9 August 2021

Re: Hume Coal Project and Berrima Rail Project (SSD 7172 and 7171) – Response to additional material provided by DPIE

Figure 1 – Permeability data for Hume Coal including 2020 data (red squares).

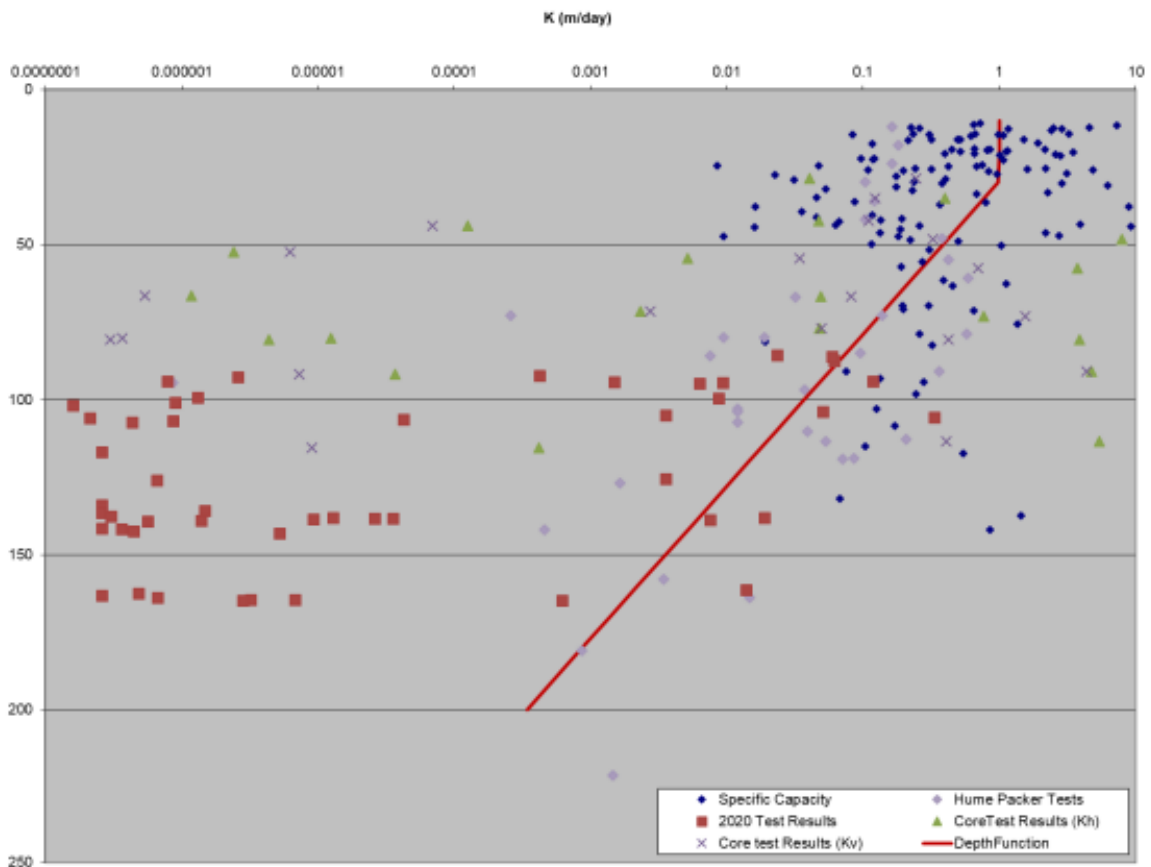
In Dr Jones' report on the "Analysis of the Wongawilli Coal to Hawkesbury Sandstone succession in the Hume Coal Project area", he notes that remnants of the Eckersley Formation and the Burragorang Claystone (volcanic ash deposit) are present and extend up to 8 m thickness and show low permeability values. Following completion of Dr Jones' report, a more detailed testing program was undertaken of core from the interburden. The below figure presents the additional data obtained from this permeability testing, which was provided to the Commission in Annexure B of the Hume Coal Response Report, and strongly demonstrates that permeability decreases with depth.
